## ANSONIA SENIOR CENTER

### Addendum #1 Questions

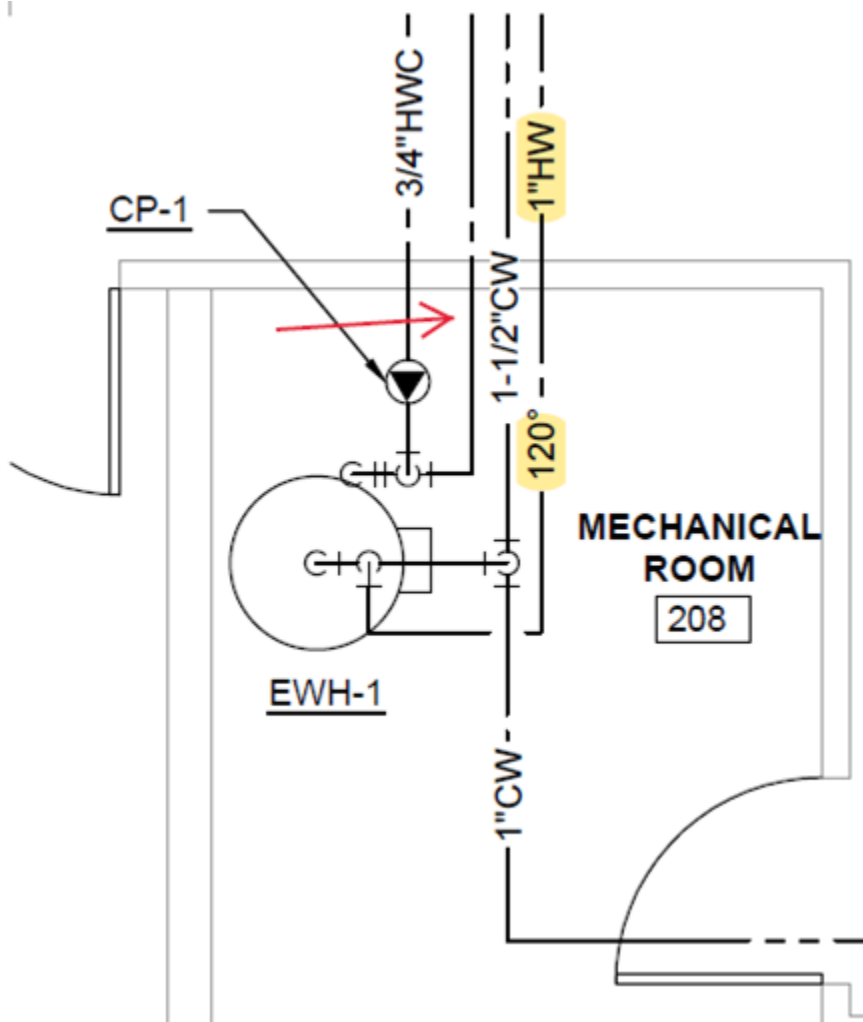
1. Please confirm the ceiling height in garage below second floor? **95" to underside of concrete beam and 124" to underside of concrete joists.**
2. Will sanitary piping be exposed to the cold? Is the existing sanitary piping insulated? Heat traced? If Insulation and or heat trace is required what are specifications?  
**The sanitary piping is installed in the ceiling space of the garage. The existing sanitary piping we believe is insulated, but will need to be verified in the field and add if not installed. Heat trace and insulation will be provided per drawing P002 attached.**
3. Will the building/space be occupied during construction? Will shutdowns and tie-ins to existing sanitary and water need to be coordinated with tenants? Owners/ management company? Please provide a roofing detail with dimensions for penetrations and curbs.

**The building will be occupied during construction. Shut downs/ tie-ins will have to be coordinated with the owner. There is no plumbing roof penetrations. For mechanical there are no roof penetrations, the refrigerant piping run through wall penetrations. The stair tower is taller than the main building. Refer to detail #6 on M402 for condensing unit rails detail.**

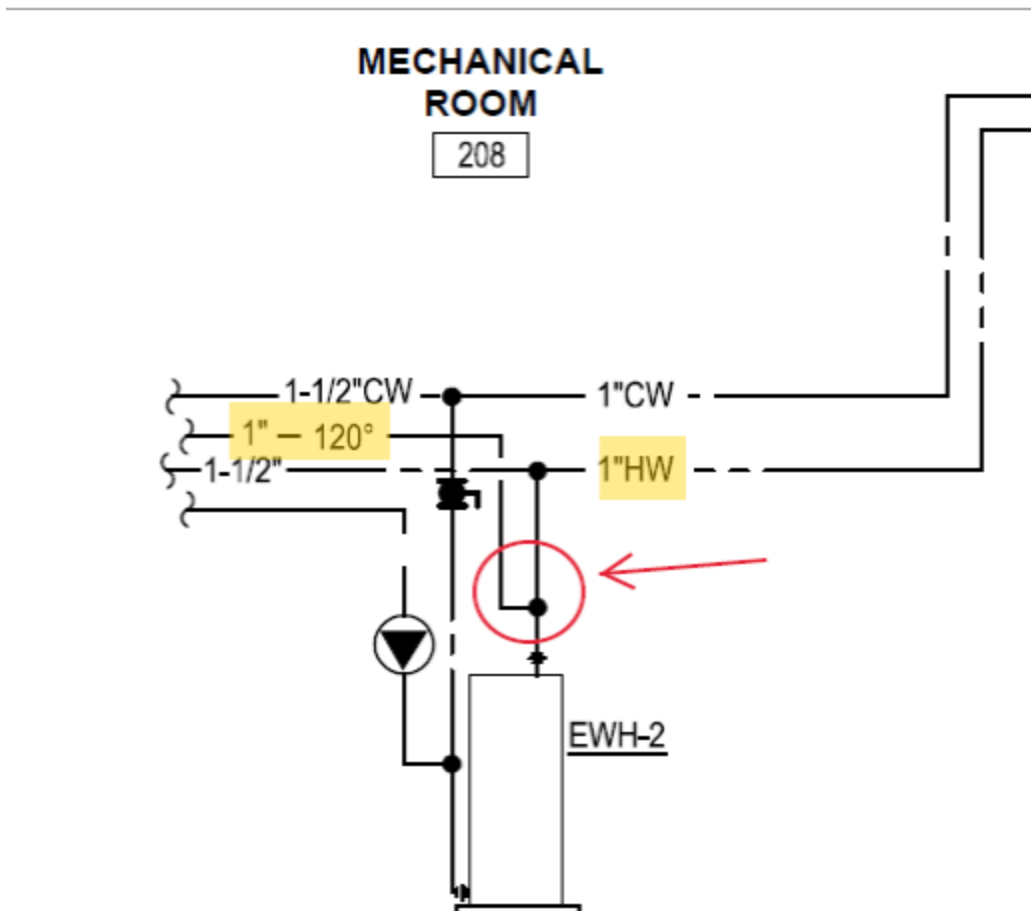
10. Is there a mixing valve somewhere on drawing that I am missing, looks like a dual temp domestic hot water system. **Yes a mixing valve is required. See sketch attached drawing P002**
